Proposed Milton Quarry East Extension JART COMMENT SUMMARY TABLE – Traffic

JART Comments (August 2022)	Reference	Source of Comment	Applicant Response (December 2022)	JART Response
Report/Date: Traffic Impact Study/ Haul Route Assessment October 2021		Author: The Municipality Infrastructure Group

Re: Proposed Dufferin Aggregates Milton Quarry East Extension – Safety Analysis Letter

Re: Proposed Dufferin Aggregates Milton Quarry East Extension – Sightline
Analysis

Figure 1 Preferred Future Haul Route

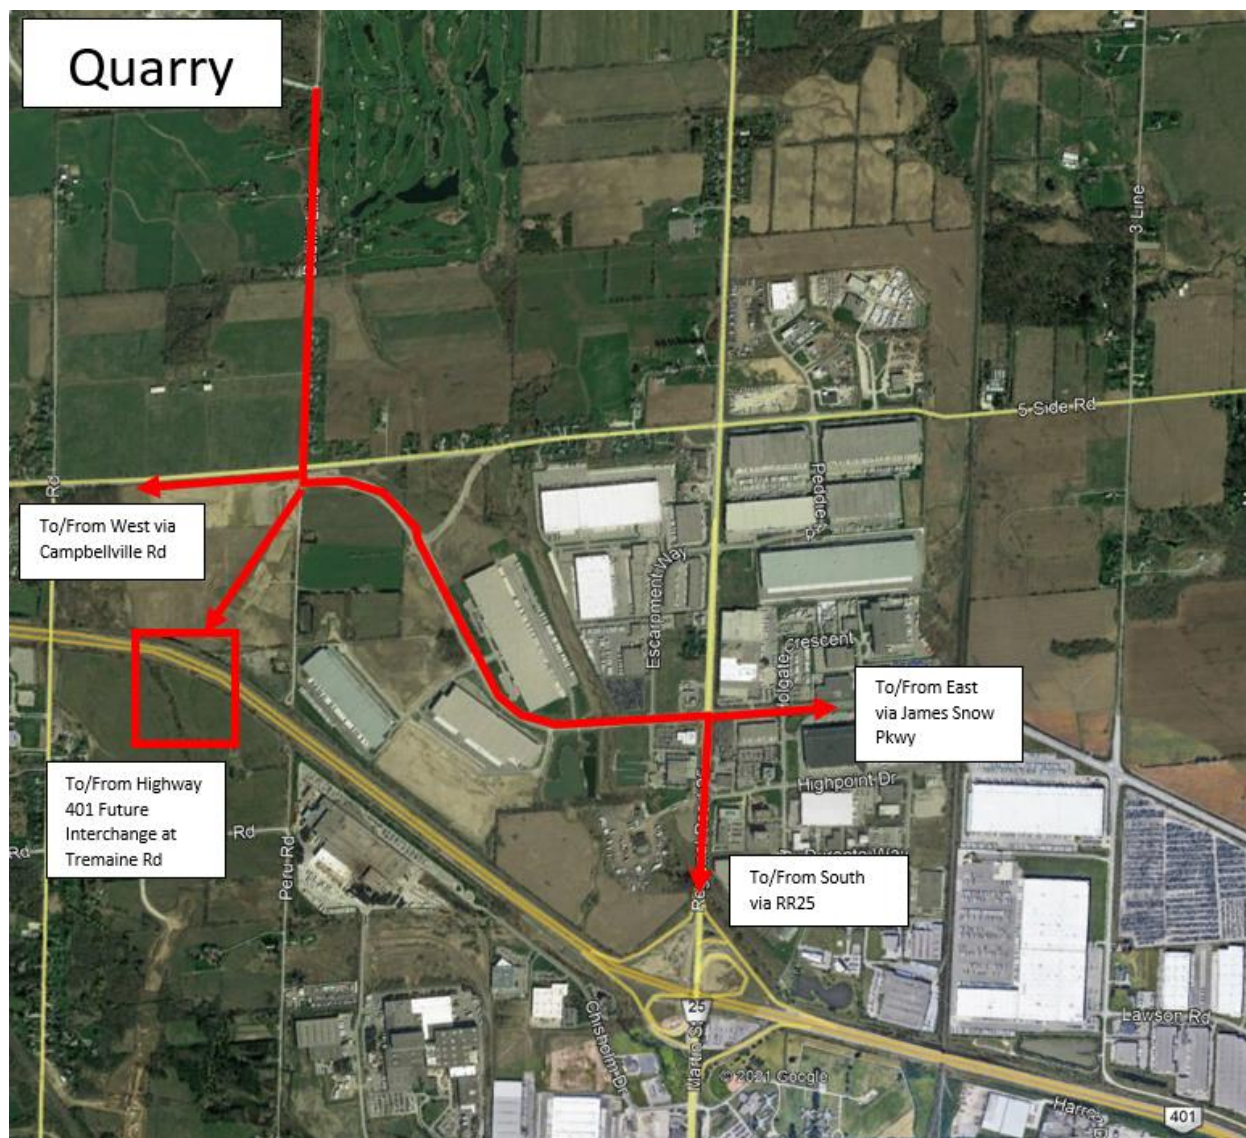
19.	<p>The following comments were made on Safety Analysis:</p> <ul style="list-style-type: none">• Discuss potential safety or operational issues (per Region's TIS Guidelines, Section 3.6.2) in the study area.• Assess the heavy truck routing to and from the quarry and provide justification and demonstrate that the proposed modified haul route is feasible from a traffic safety perspective. <p>This has not been addressed: A Safety Analysis was not discussed.</p>		CIMA+	<p>This was addressed in TYLin's Safety letter and Sightline Memo dated March, 2022, and July 2022 respectively (Attachments #1 & #2).</p>

Please refer to **Figure 1** for an illustration of the future haul route assessed as part of this safety analysis.

Based on the nominal volume of non-quarry related traffic crossing the quarry access, the access is expected to operate with an acceptable level of service allowing for ample gaps for vehicles attempting to enter Dublin Line. As a result, there are no concerns for trucks merging to/from the access and the roadway, with no need to weave along Dublin Line per its two-lane cross-section. Furthermore, along the haulage route, the majority of trucks will travel north-south through the roundabout to access Tremaine Road and the Highway 401 interchange, while select vehicles will travel onto James Snow Parkway and Campbellville Road as illustrated in **Figure 1**.

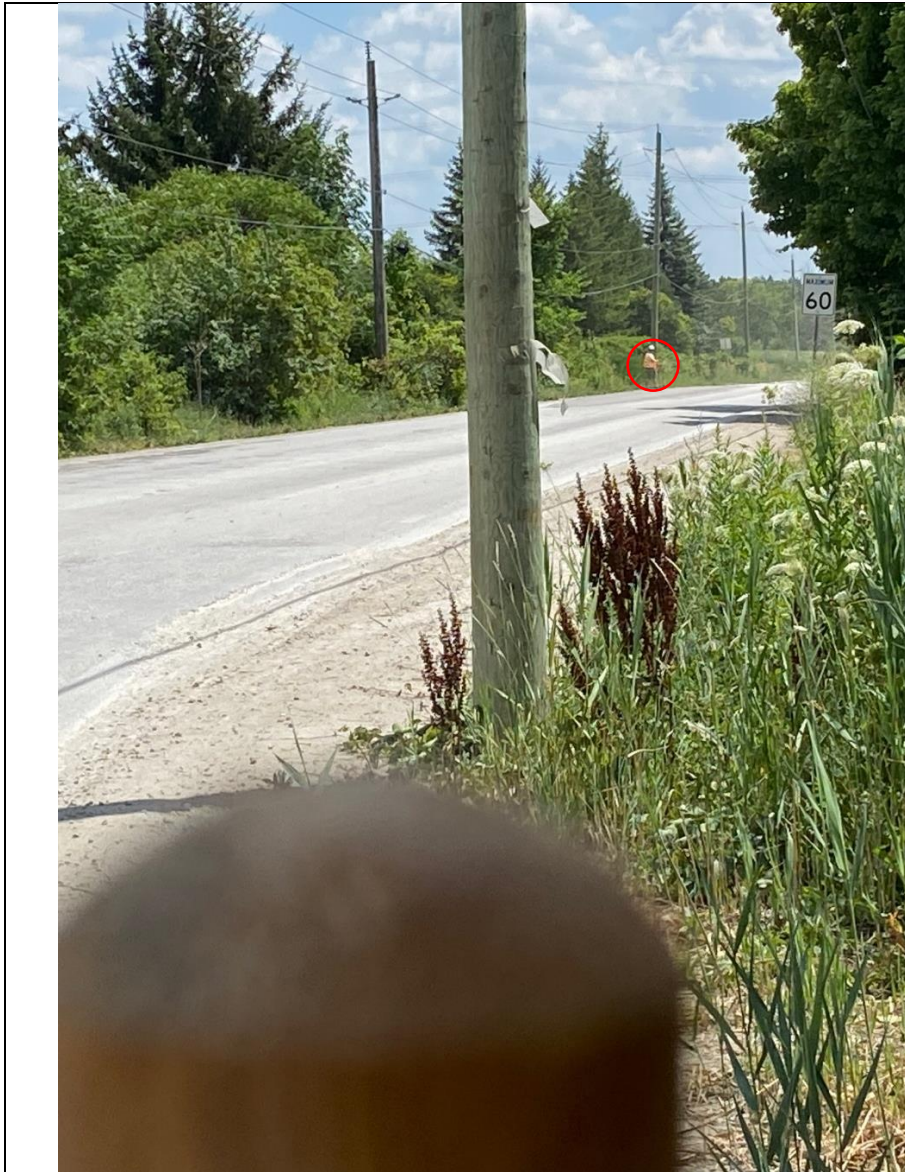
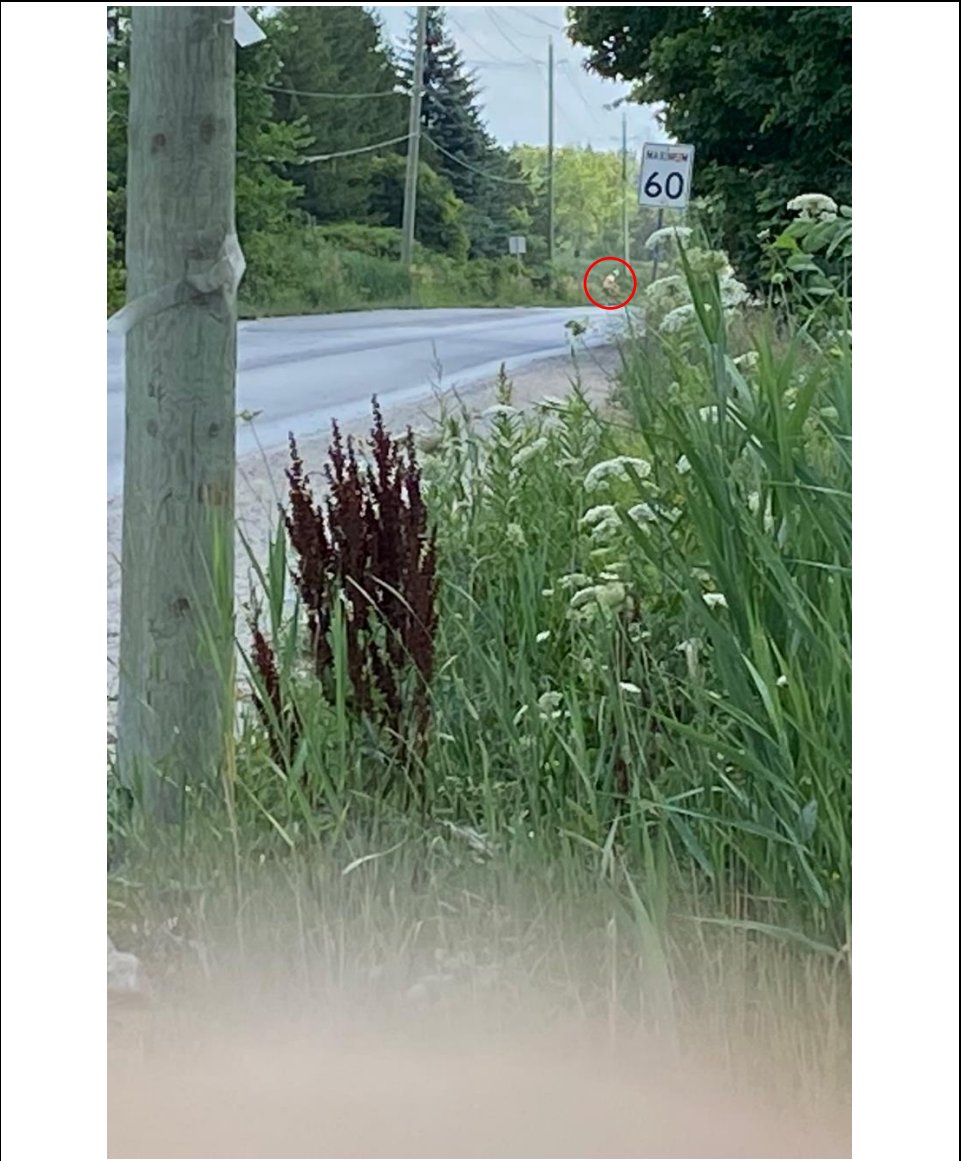
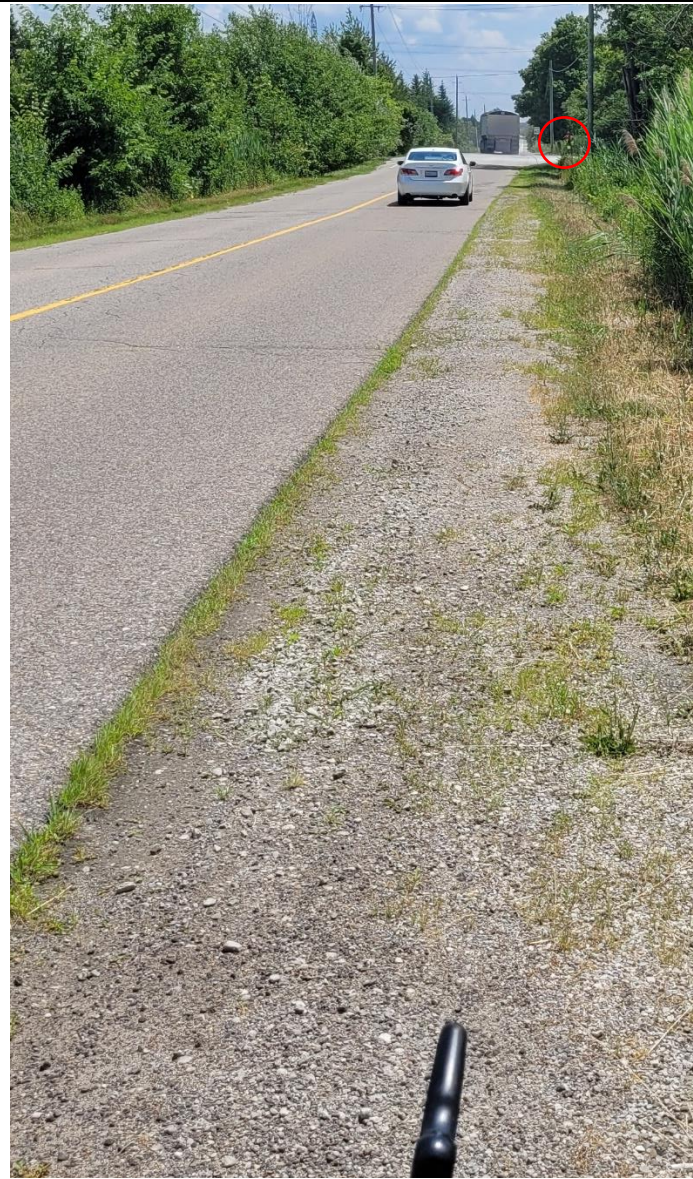
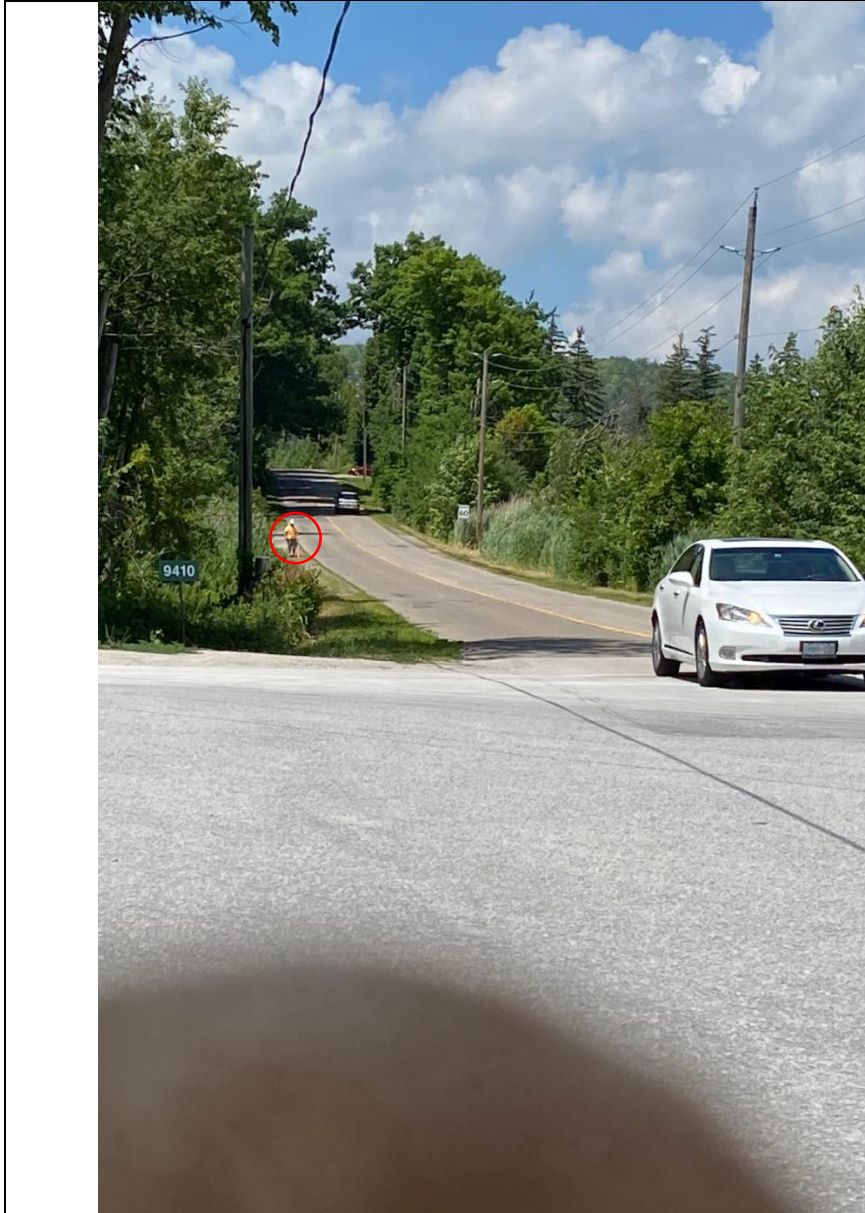
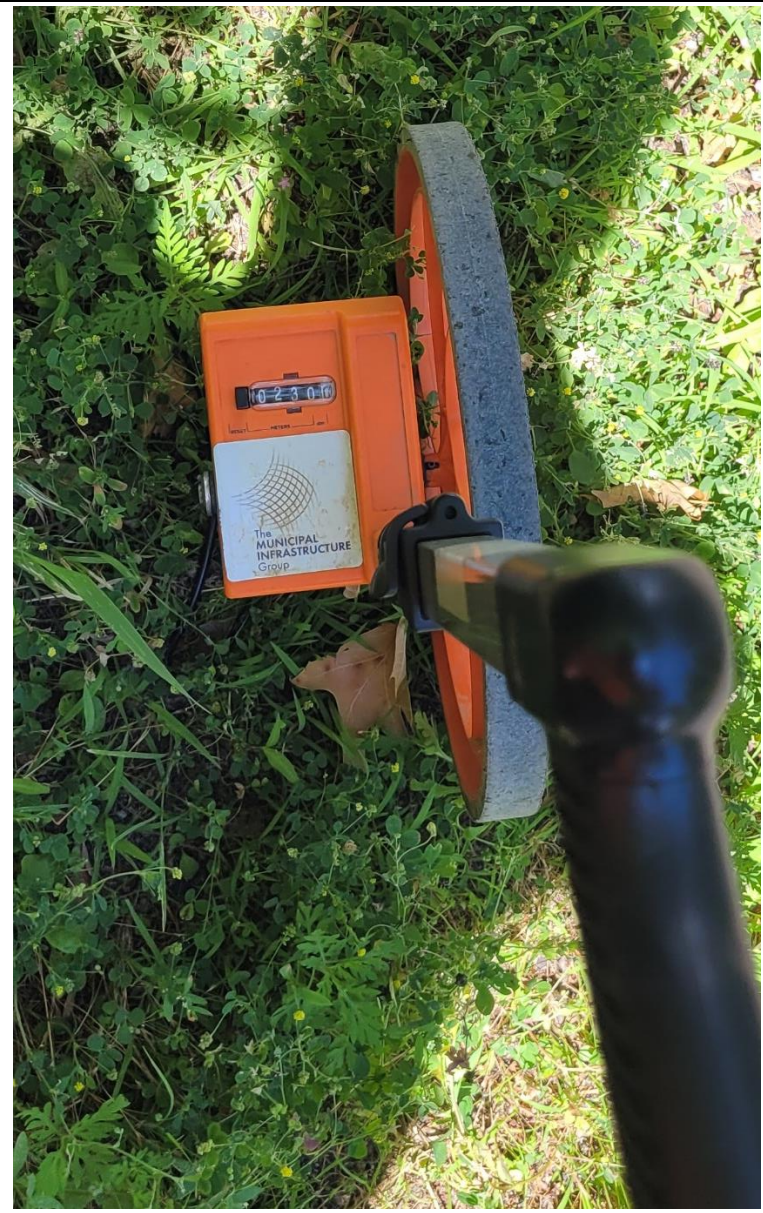
11.	Update the TIS pertaining to the Dublin Line access pertaining to operational review (i.e., collisions, sightlines). Provide a figure with an aerial, confirming sightlines are met.		Town of Halton Hills	<p>This was addressed in TYLin’s Safety letter and Sightline Memo dated March, 2022, and July 2022 respectively (Attachments #1 & 2).</p>

Pre-Consultation Inquiries					
21.	<p>The following comments were made on Operational Review about the Dublin Line and Main Access - operational review (i.e., collisions, sightlines).</p> <p>This has not been addressed:</p> <p>Response (shown below) was a review based on solely aerial and street imagery. Not site visit was conducted to confirm sightlines.</p> <p>A collision analysis or influence of heavy truck traffic on safety was not mentioned in the report.</p> <p>Response: Dublin Line is a relatively flat and straight roadway, with a posted speed limit of 60km/h. Based on the Transportation Association of Canada (TAC) Geometric Design Standards (2017), a stopping sight distance requirement of 130m is applicable to a design speed of 80km/h (assuming 20km/h over the posted speed</p> <p>CRH Canada Group Inc. Traffic Impact Study/ Haul Route Assessment Dufferin Aggregates Milton Quarry East Extension TMIG PROJECT NUMBER 10108 limit). Based on the vertical and horizontal curvature of the roadway (as reviewed based on aerial on</p>		CIMA+	<p>This was addressed in TYLin's Safety letter and Sightline Memo dated March, 2022, and July 2022 respectively (Attachments #1 & #2).</p>

The field observation confirmed that both the minimum SSD of 130 metres as well as the DSD of 230 metres were met on Dublin Line both north and south of the quarry access. As the DSD was met, it was inferred that the ISD requirement was also satisfied. TYLin staff members were able to observe both the 0.6-metre and 1.3-metre-high object approaching from the north, while from the south the 1.3 metre-high object was visible at both distances. Although the 0.6 metre-high object was not visible from the south, the sightline was still deemed acceptable given that the 1.3-metre high object was observed, indicating that vehicles entering Dublin Line from the quarry access will be able to see a vehicle approaching from the south at the desired distance. Photos documenting the sight distances are included in **Attachment 2**, in which photos from the SSD and DSD both south and north of the quarry access were taken at the driver's eye height.

In conclusion, the applicable SSD and DSD requirements for the Milton Quarry access were deemed to be met based on field observation by TYLin staff (thereby also meeting ISD requirements).
